Product Change Notice (PCN)

Subject: Change Shipping Media on Select Package

Publication Date: 10/30/2020

Appendix B - Shipping Tray Comparison

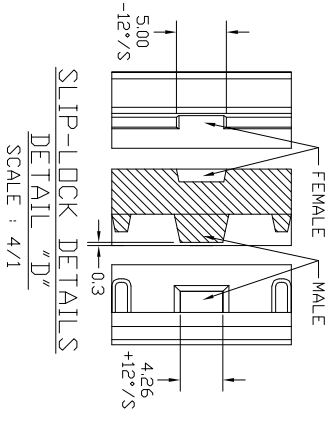
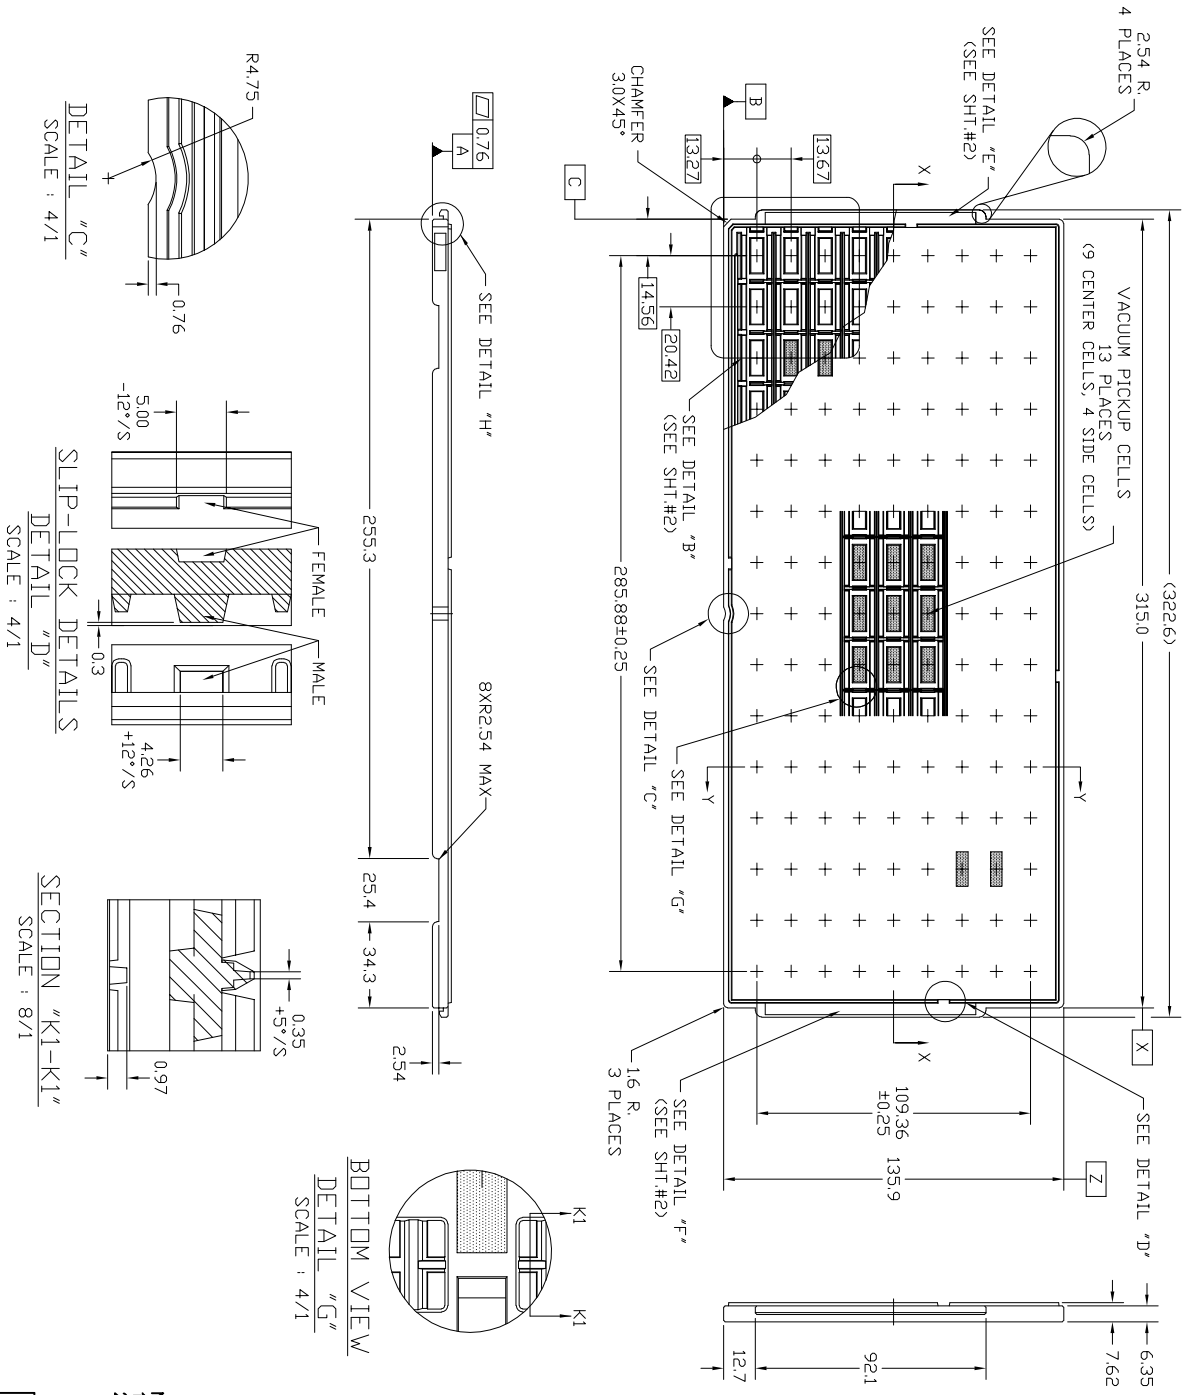
An Industrial standard JEDEC shipping tray will be introduced. In addition, one of the Orderable Part# that is presently ship in Tray (Tray part# 124-4725-119) will convert to the new Tray (New Tray part# TR142050). The MOQ and FOI in Tray shipment shall change to 135 units. Refer Appendix A and Appendix B for more information.

Descriptions	Current (Shipping Tray, part# 124-4725-119)	New (Shipping Tray, part# TR142050)
Supplier	DAEWON	DAEWON
Tray Material	MPPO	MPPO
Tray Matrix	8x12	9x15
Units Per Tray	96	135
Row Pitch	15.16 mm	13.67 mm
Colum Pitch	25.50 mm	20.42 mm
